**Subject:** San Mateo Park Elementary School HVAC Replacement  
San Mateo - Foster City School District  
Aedis Project No. 2021011.08  
DSA Application #01-120214

### ADDENDUM NO. 1

San Mateo Park Elementary School HVAC Replacement  
San Mateo – Foster City School District  
Aedis Project No. 2021011.08

SHEET # **AD1-  
MP3.01**

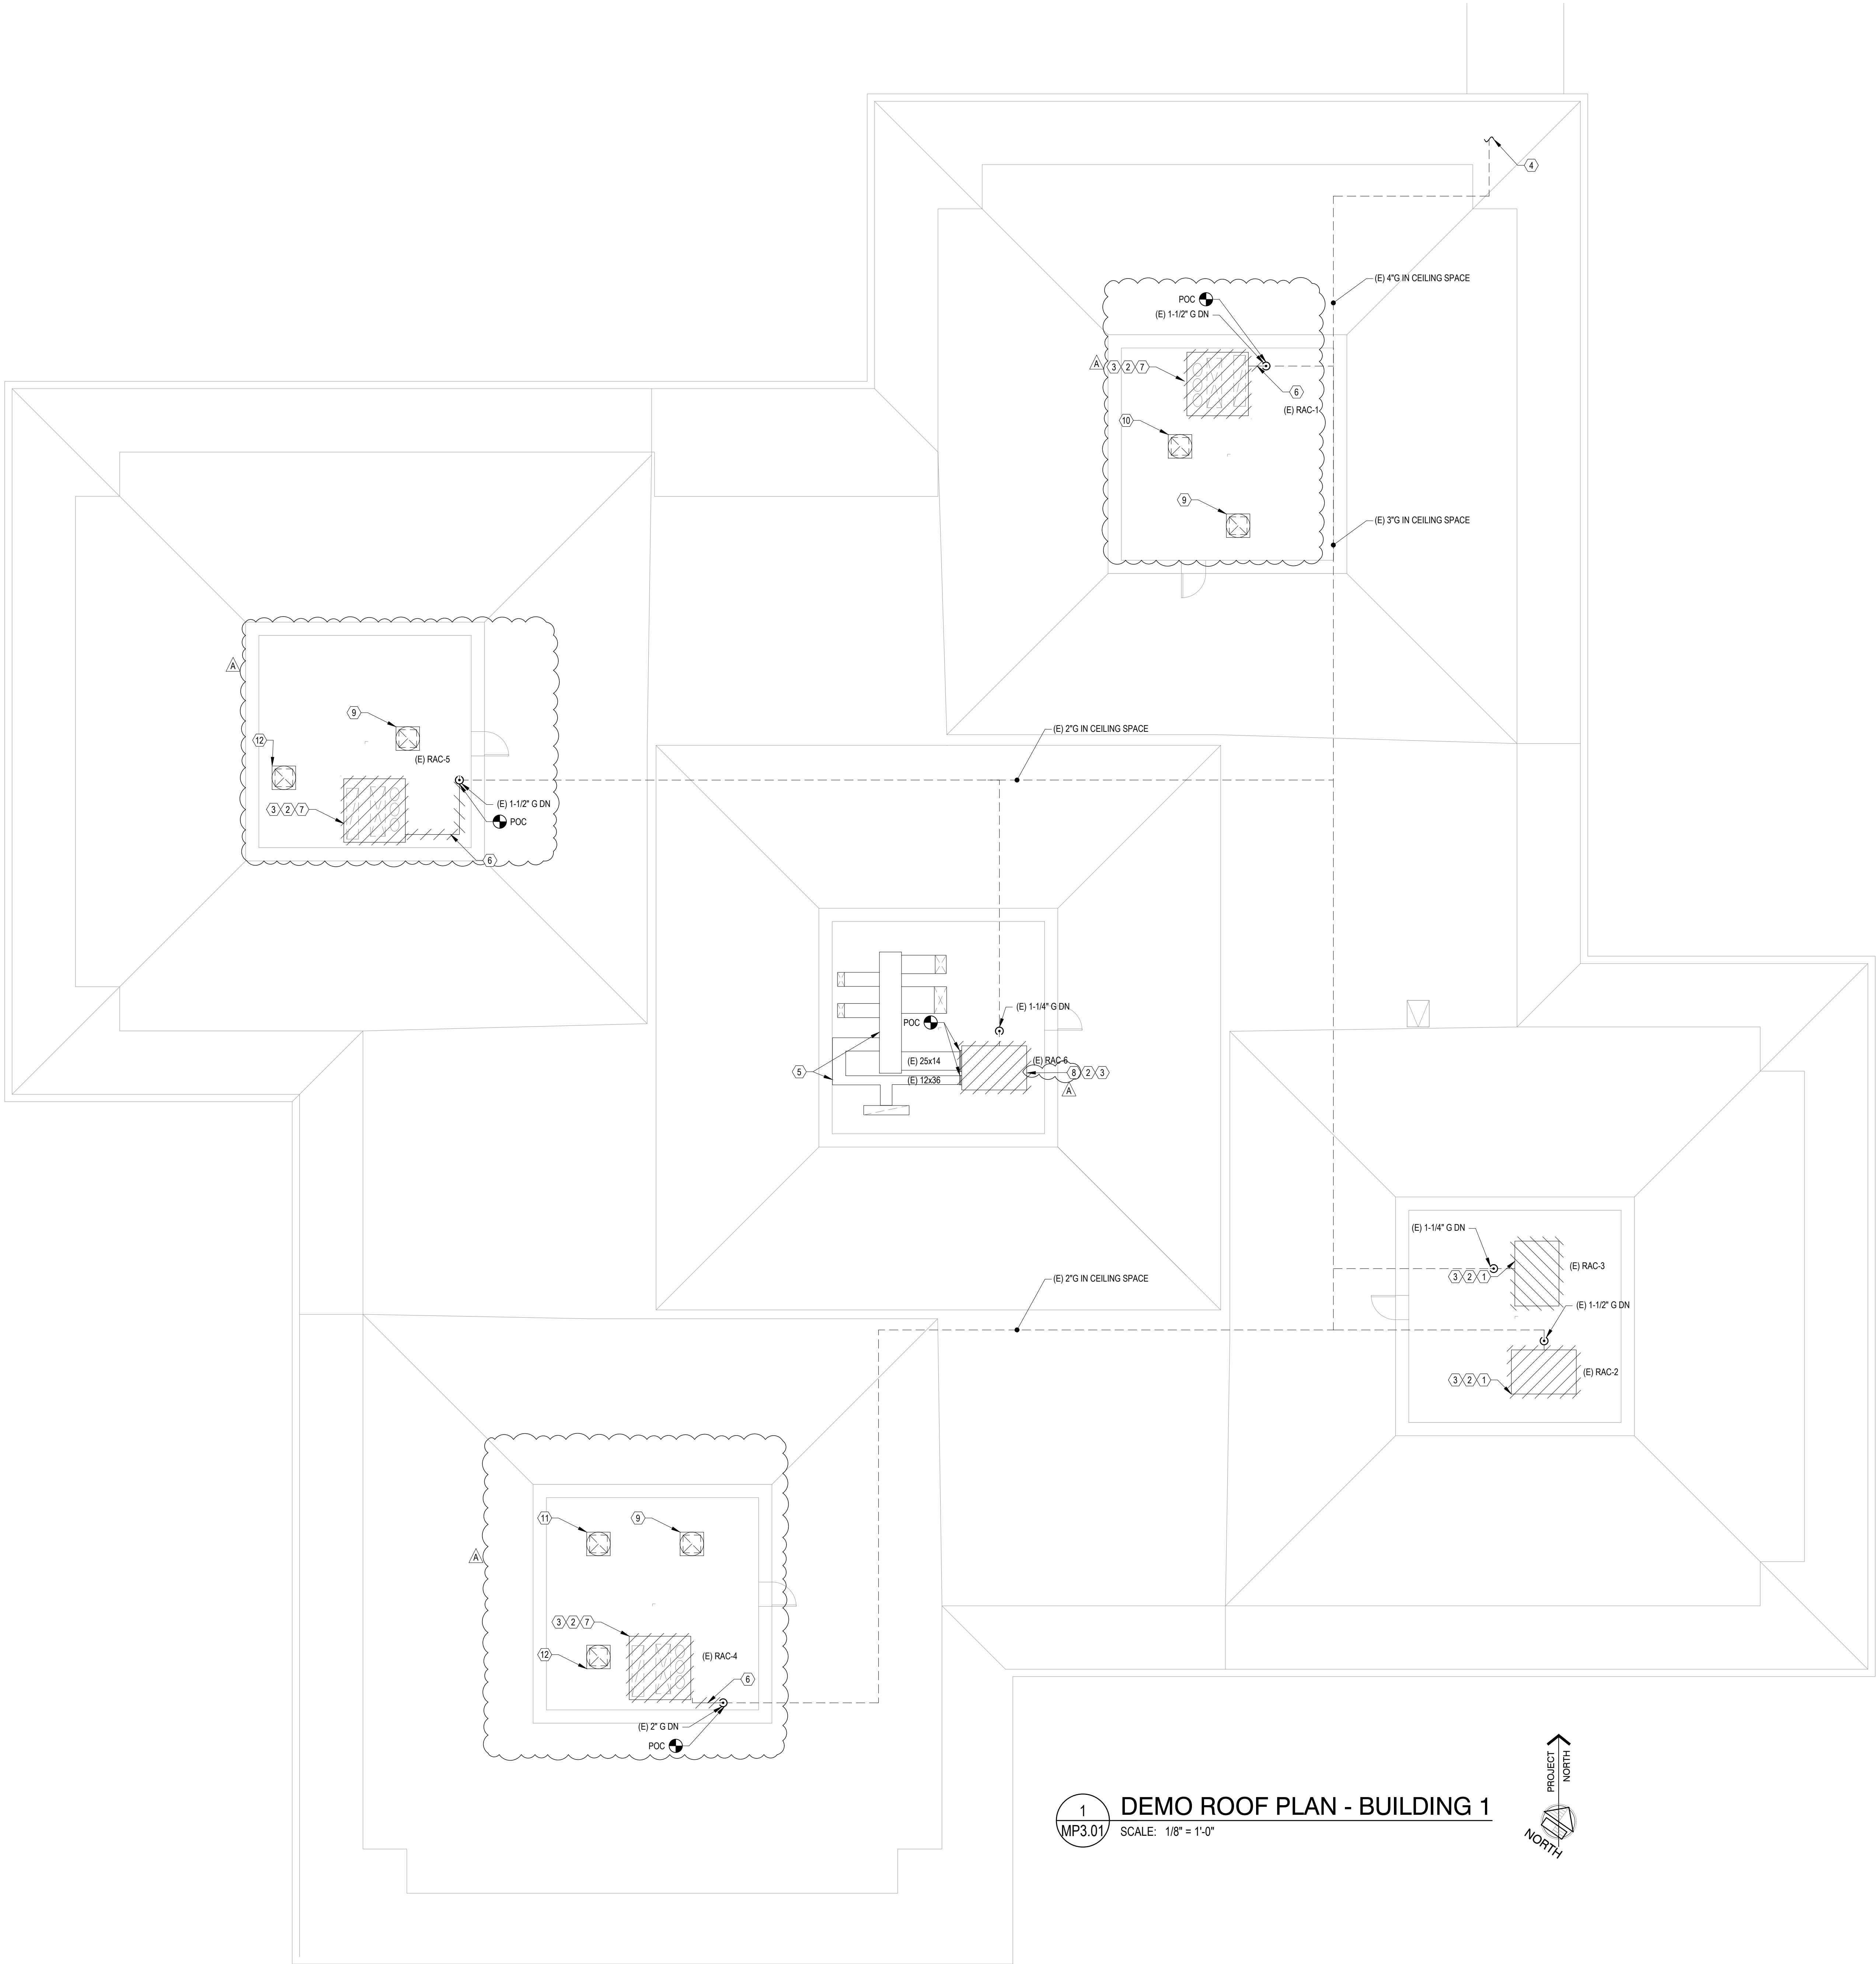
Add: Demolition Sheet Notes #6, #7, #8, #9, #10, #11, #12 and associated tags in plan as shown per AD1-MP3.01

Revise: (E) RAC-4 call out with (E) RAC-1 call out in plan as shown per AD1-MP3.01

Add: (E) exhaust fans added to plans as shown per AD1-MP3.01.

Add: (E) relief vents added to plans as shown per AD1-MP3.01.

DATE 11/28/2022  
JOB # 2021011.08  
SHEET # AD1-  
MP3.02

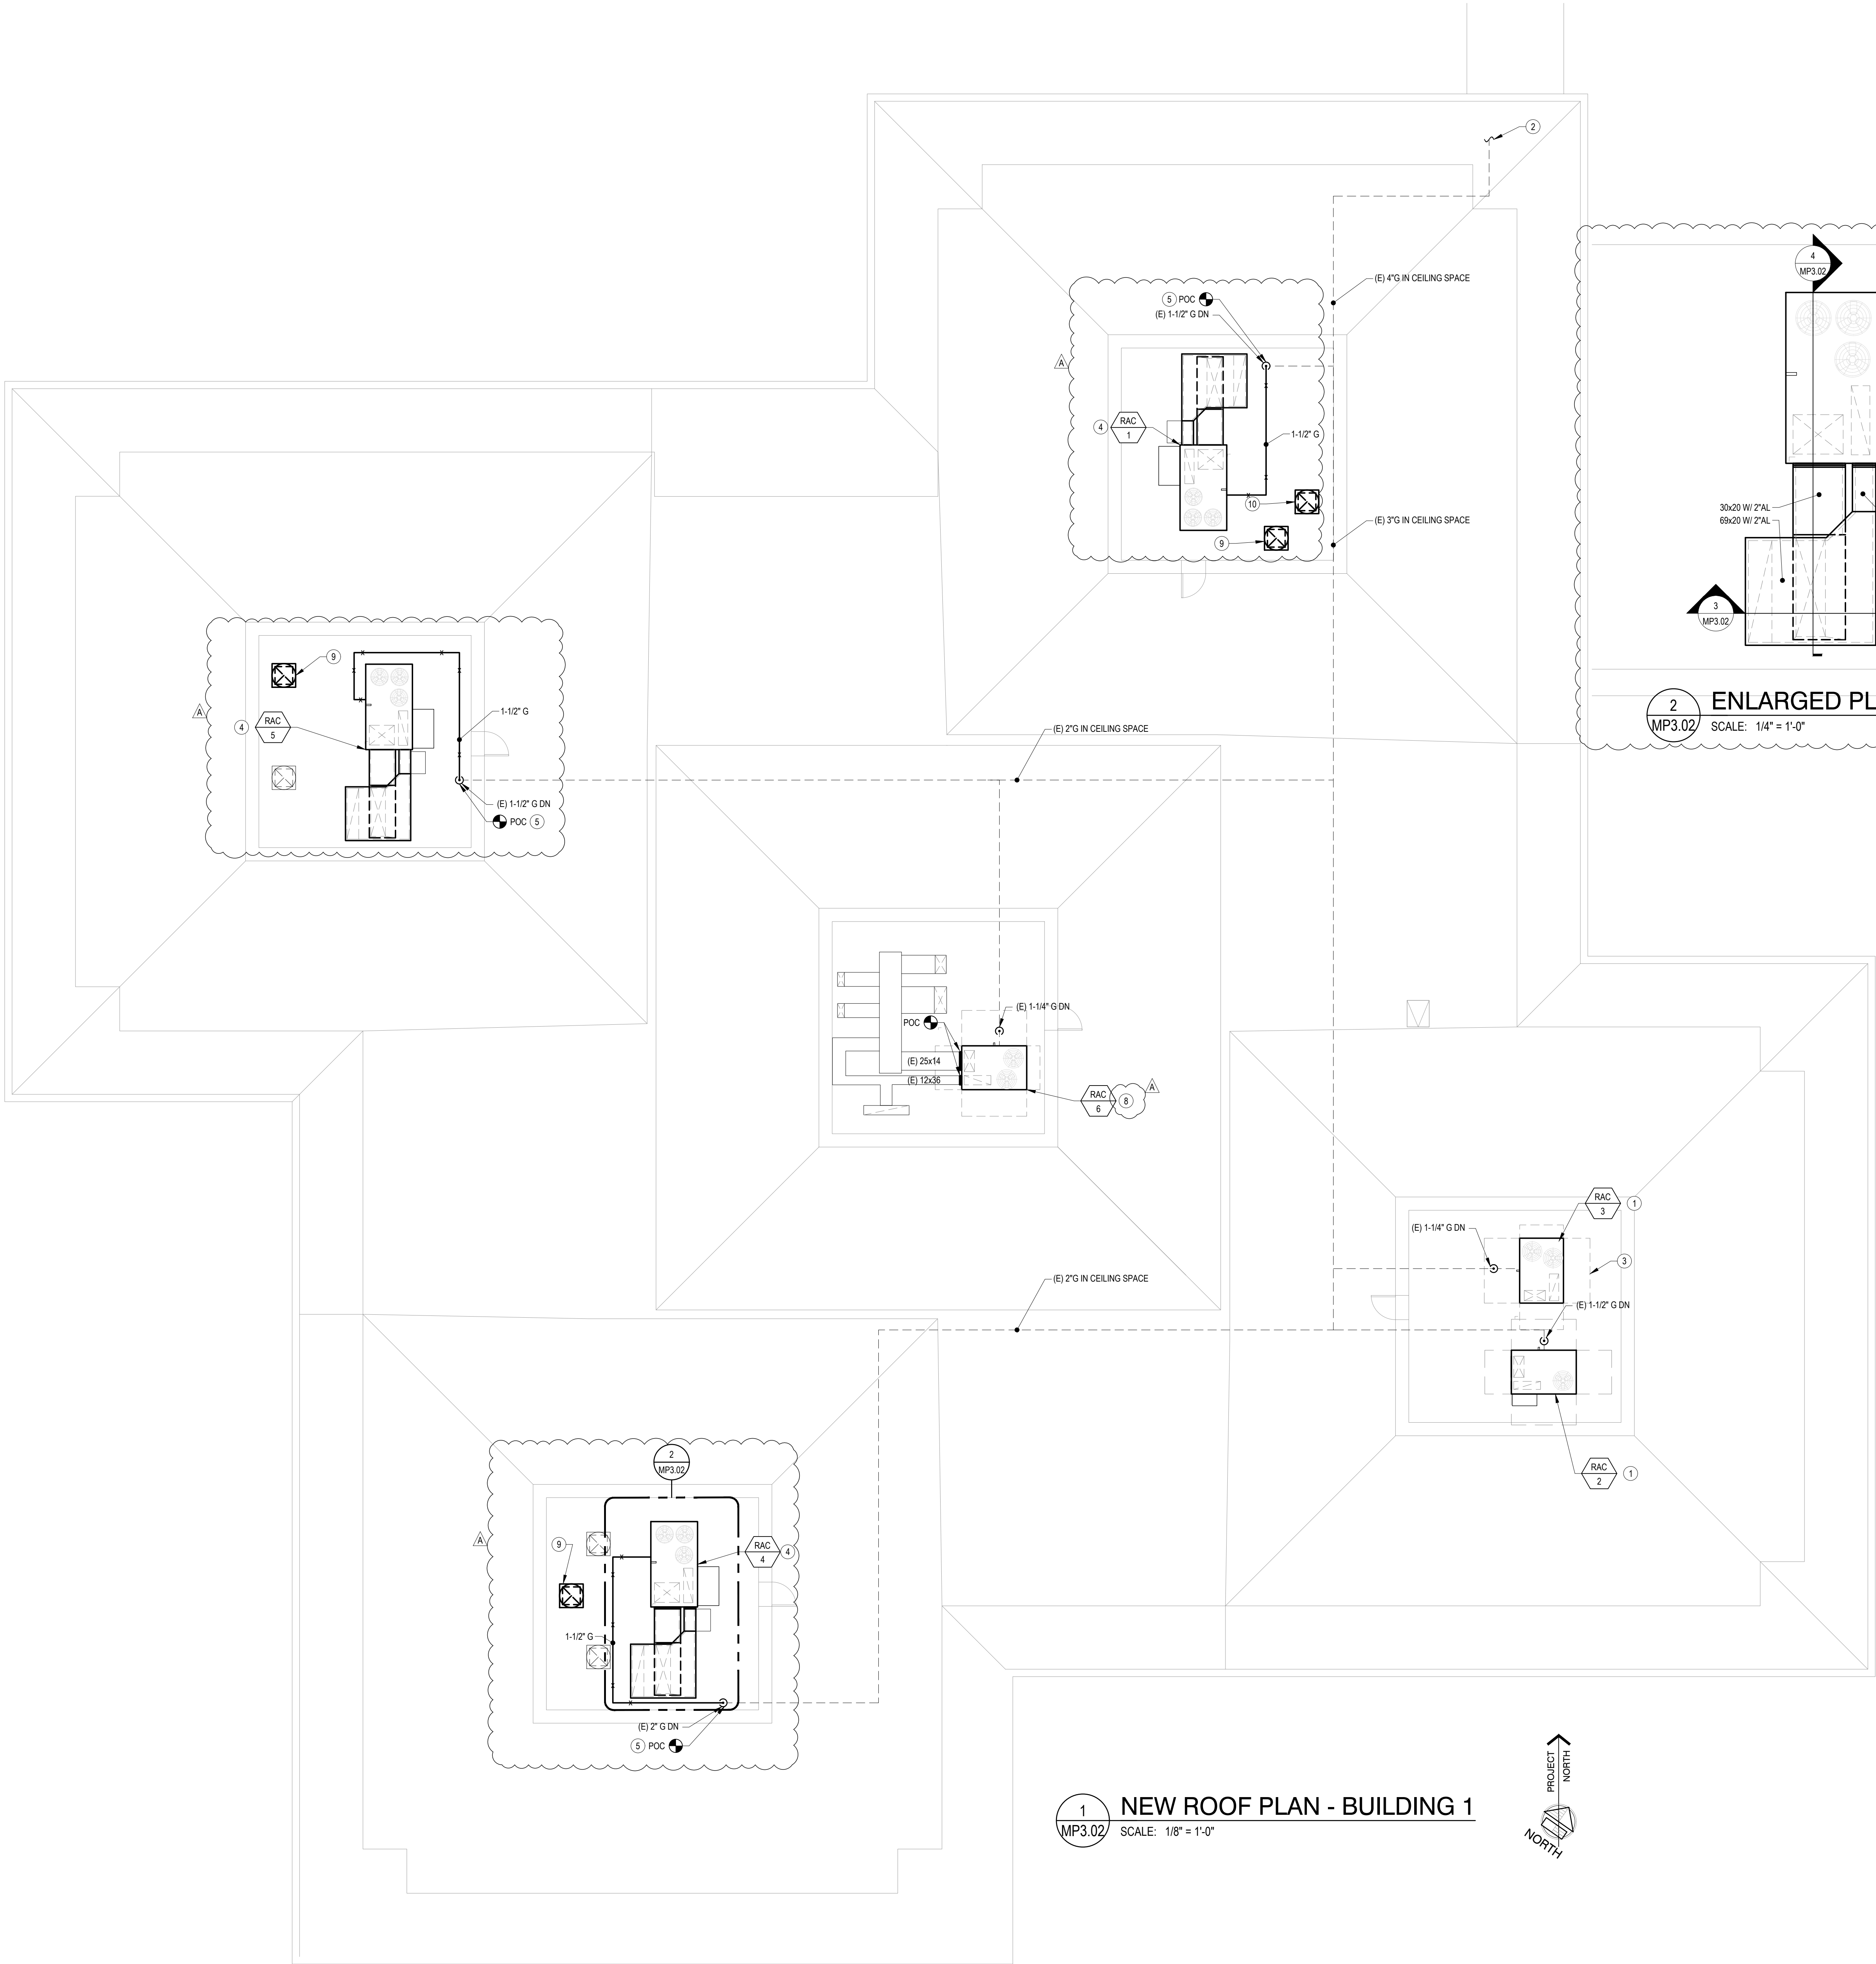
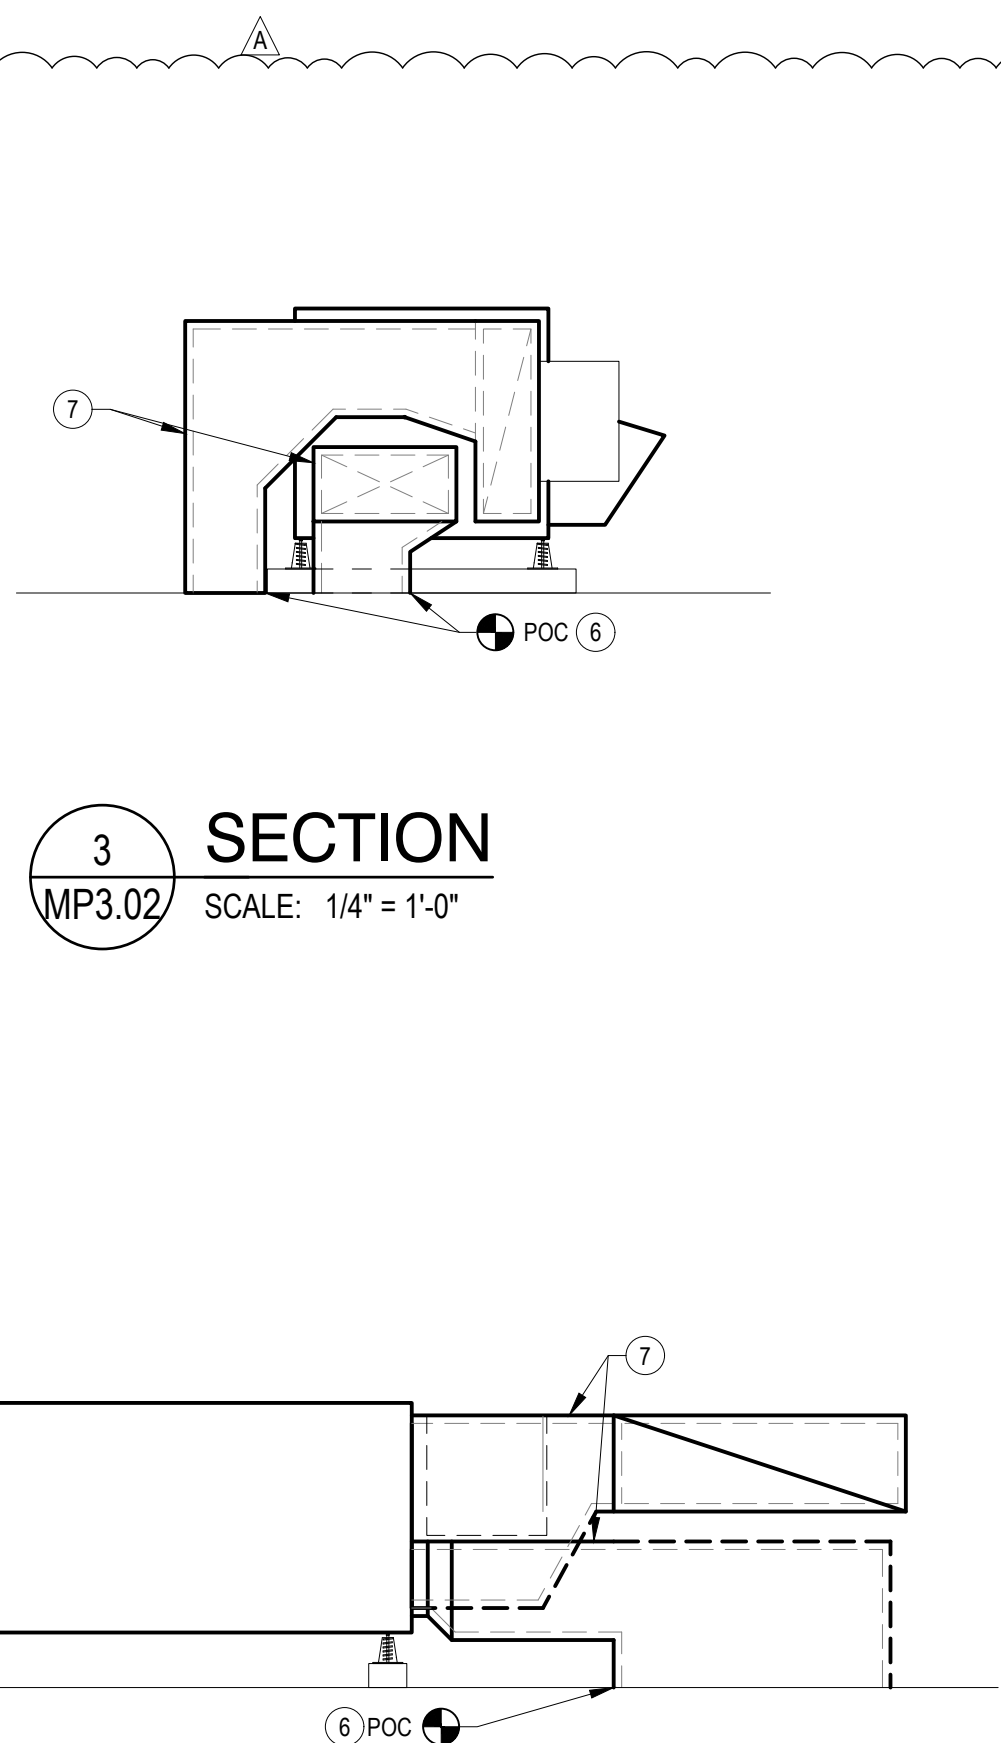
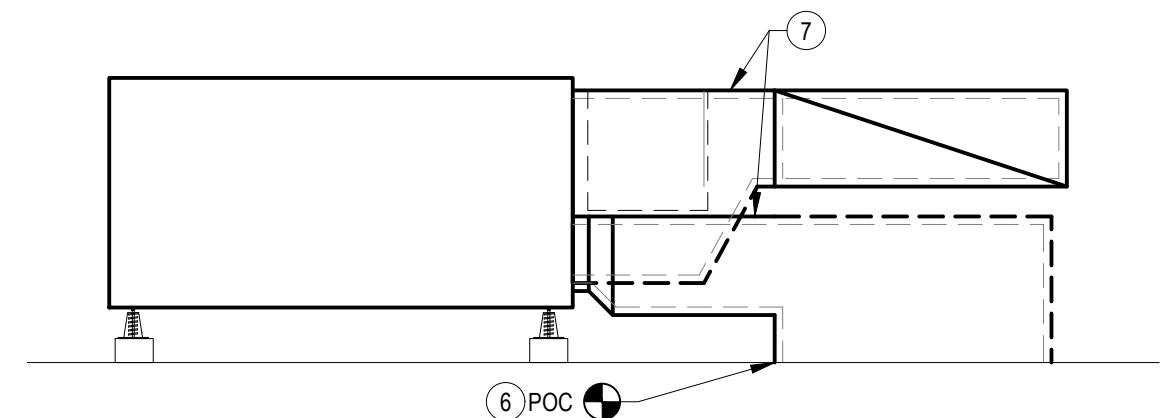
Revise: Location of RAC-1, RAC-4 & RAC-5 as shown per AD-MP3.02

Add: New Sheet Notes #4, #5, #6, #7, #8, #9, #10 and associated tags in plan as shown per AD1-MP3.02

Add: Enlarged Plan 2 and associated call out in plan as shown per AD1-MP3.02.

Add: Sections 3 & 4 as clouded per AD1-MP3.02.

Add: (E) exhaust fans and vents added to plan as shown per AD1-3.02.
